Marulan Gas Turbine Facilities

Submissions Response & Preferred Project Report

May 2009

Date: 12 May 2009
Reference: 43177371/ 43177585
Status: FINAL

<div>Client</div> <div>DELTA ELECTRICITY AND ENERGY AUSTRALIA</div>	<div>Project</div> <div>MARULAN GAS TURBINE FACILITIES – SUBMISSIONS RESPONSE AND PREFERRED PROJECT REPORT</div>	Title		<div>Figure: 4-9</div>
		Drawn: AO Approved: NB Date: 11/03/2009		
		Job No: 43177371 File No: 43177371-227.wor

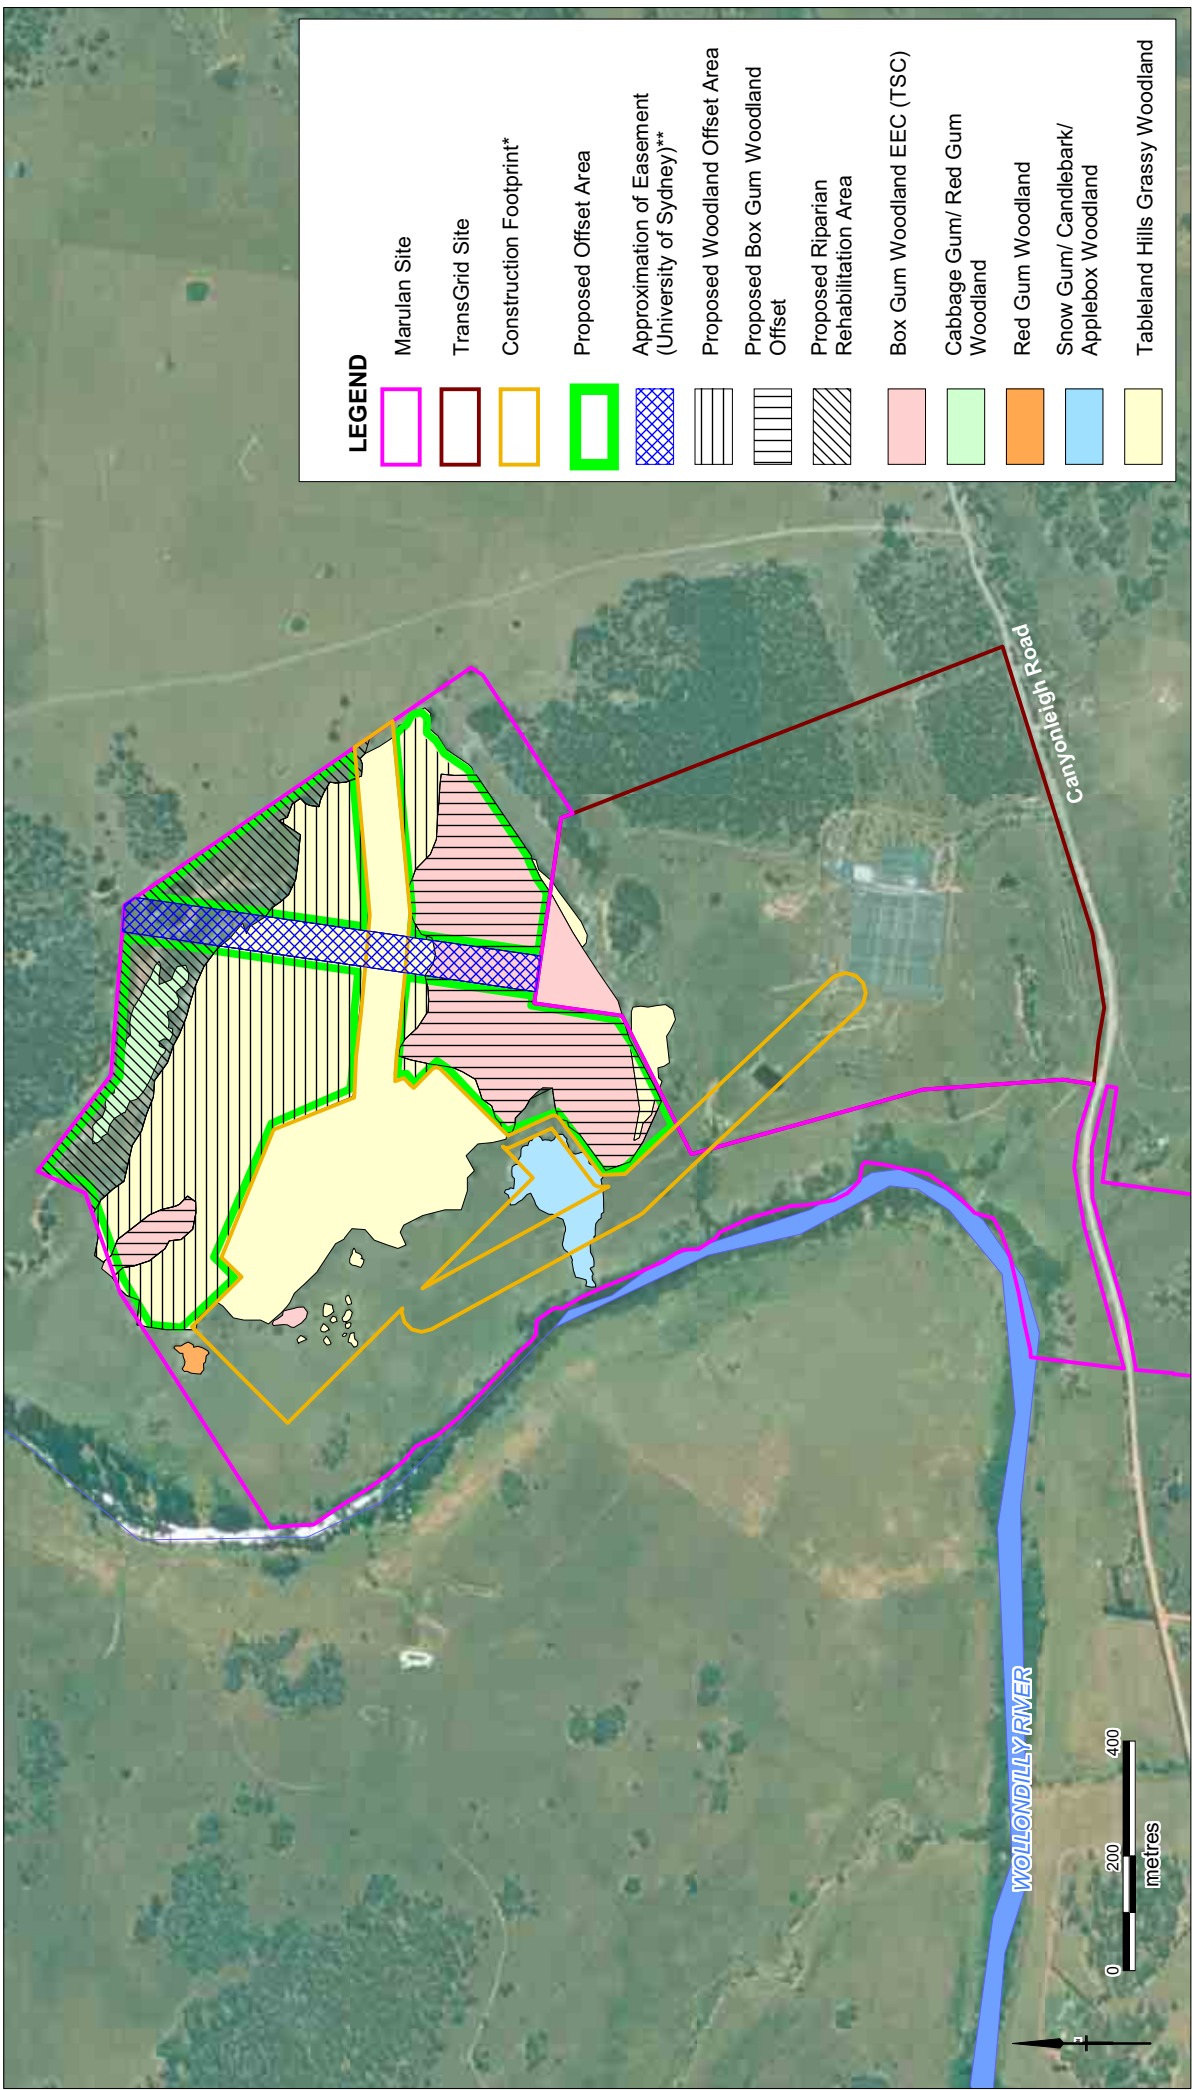
Submission CMA.04: It is understood that Priority E4 of the NSW State Plan, the Catchment Condition Targets of the Hawkesbury-Nepean Catchment Action Plan, and the objects of the NV Act represent NSW government policy on native vegetation. Collectively, these require a maintenance or increase in the extent of native vegetation, an improvement in native vegetation condition, and the need for clearing of native vegetation to result in an "Improved or Maintained" environmental outcome through the use of secured off-set areas.

A summary of the Project Biodiversity Offset components is provided in **Table 4-14** and presented on **Figure 4-9**.
